McNary Reservoir and Lower Snake River Reservoirs

APPENDIX A Hydrologic Analysis

**FINAL DREDGED MATERIAL MANAGEMENT PLAN AND
ENVIRONMENTAL IMPACT STATEMENT
McNary Reservoir and Lower Snake River Reservoirs**

**ERRATA SHEET
FOR
APPENDIX A - HYDROLOGIC ANALYSIS**

PLATE 7

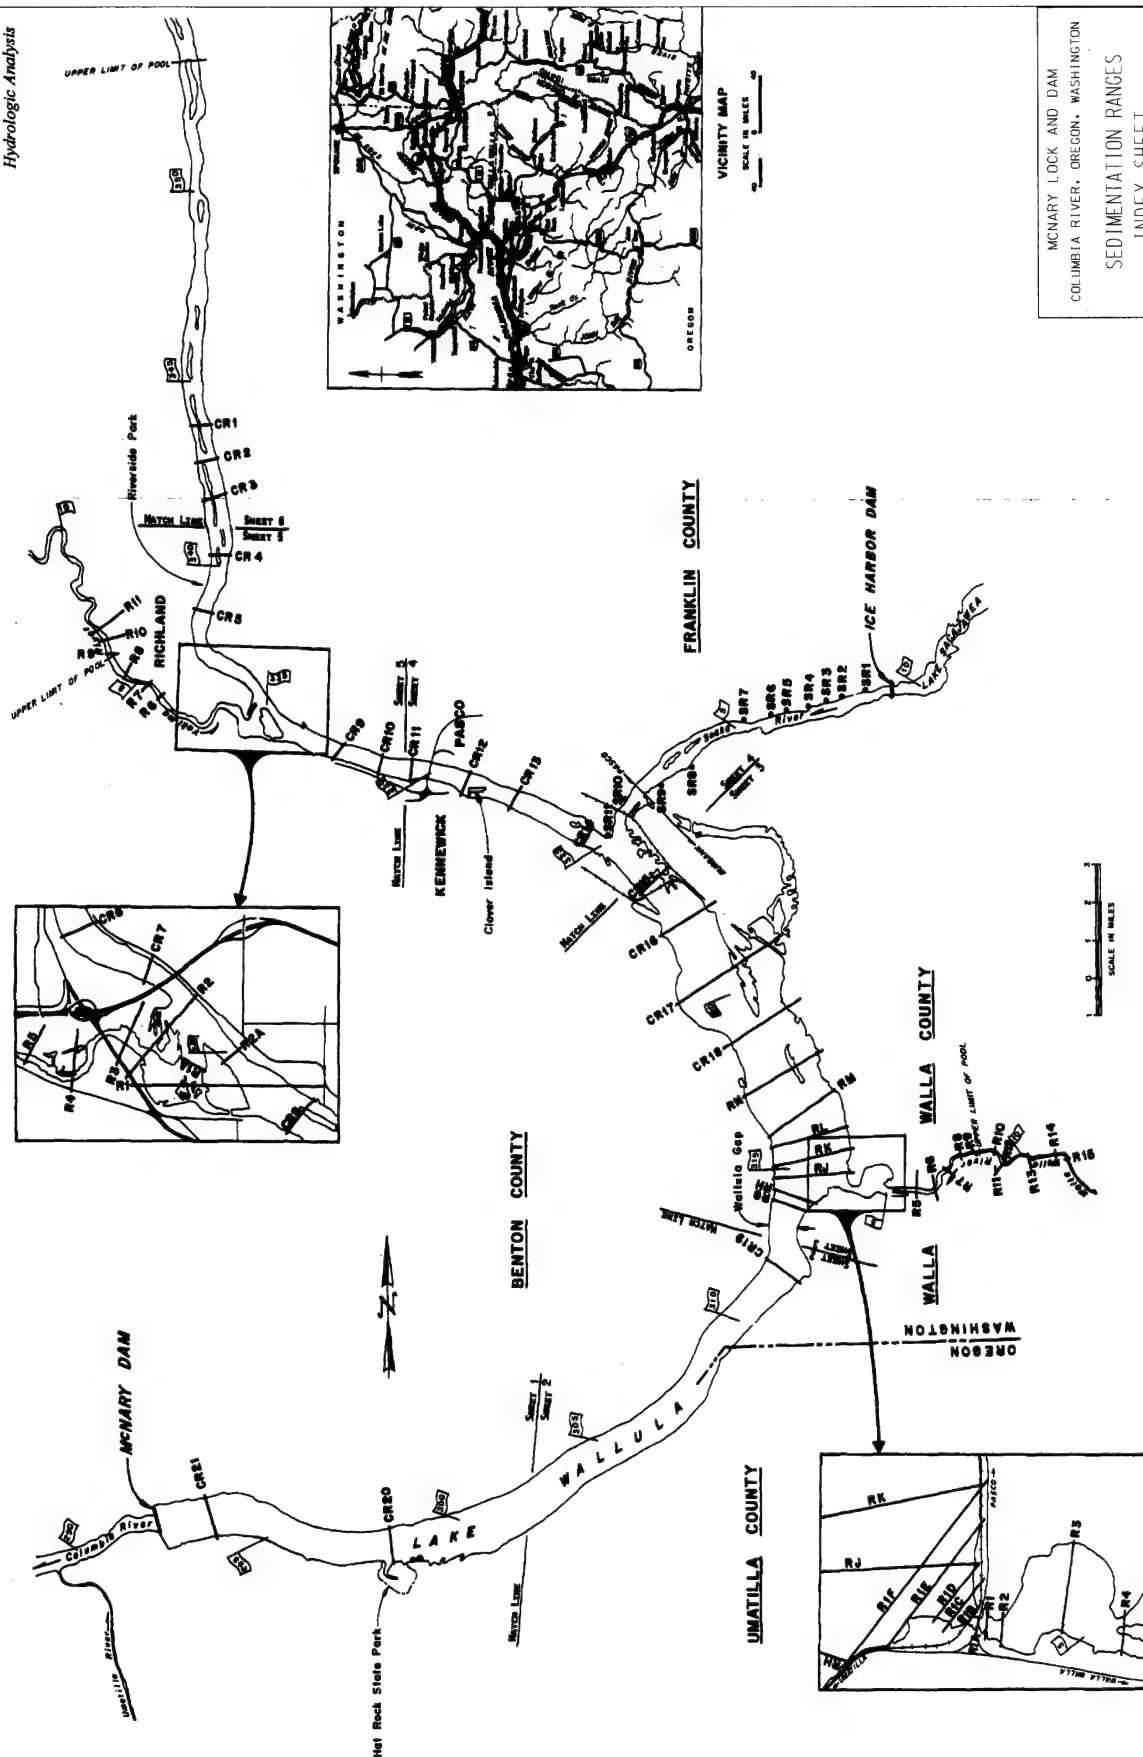
Title of Plate 7 should be: Columbia River in McNary Reservoir Sedimentation Ranges
